<b>Title - Sujet</b> Concrete Wharf Repairs	
<b>Solicitation No. - N° de l'invitation</b> F1700-150940/A	<b>Amendment No. - N° modif.</b> 003
<b>Client Reference No. - N° de référence du client</b>	<b>Date</b> 2016-02-12
<b>GETS Reference No. - N° de référence de SEAG</b> PW-\$PWY-019-7728	
<b>File No. - N° de dossier</b> PWY-5-38353 (019)	<b>CCC No./N° CCC - FMS No./N° VME</b>
<b>Solicitation Closes - L'invitation prend fin</b> <b>at - à 02:00 PM</b> <b>on - le 2016-02-18</b>	<b>Time Zone</b> <b>Fuseau horaire</b> Pacific Standard Time PST
<b>F.O.B. - F.A.B.</b> <b>Plant-Usine:</b> <input type="checkbox"/> <b>Destination:</b> <input checked="" type="checkbox"/> <b>Other-Autre:</b> <input type="checkbox"/>	
<b>Address Enquiries to: - Adresser toutes questions à:</b> Ngan, Ken (PWY)	<b>Buyer Id - Id de l'acheteur</b> pwy019
<b>Telephone No. - N° de téléphone</b> (604) 658-2755 ( )	<b>FAX No. - N° de FAX</b> (604) 775-6633

<b>Destination - of Goods, Services, and Construction:</b> <b>Destination - des biens, services et construction:</b> DFO - Institute of Ocean Sciences Wharf - Patricia Bay, BC

This Solicitation Amendment 003 is raised to incorporate Addendum #2, and to incorporat

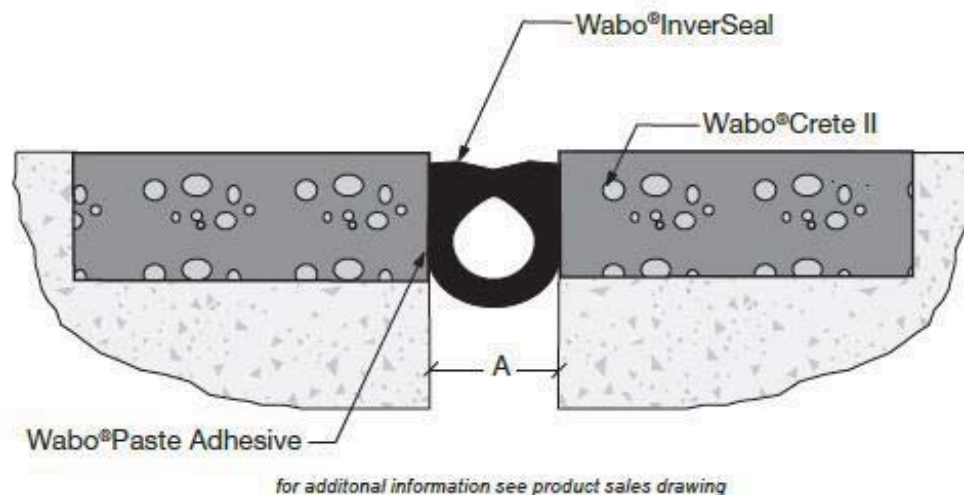
*Expansion joints shall be refurbished to match existing refurbished expansion joints. It shall include a rubber expansion joint seal set into a flexible polymer mortar. Allow for sawcutting and preparing the edge of the concrete deck as shown in the sketch below. Quantity per Unit rate table, Pay Item #6 (attached). Bid value to reflect use of Wabocrete Flexfoam Model No IV 250.*
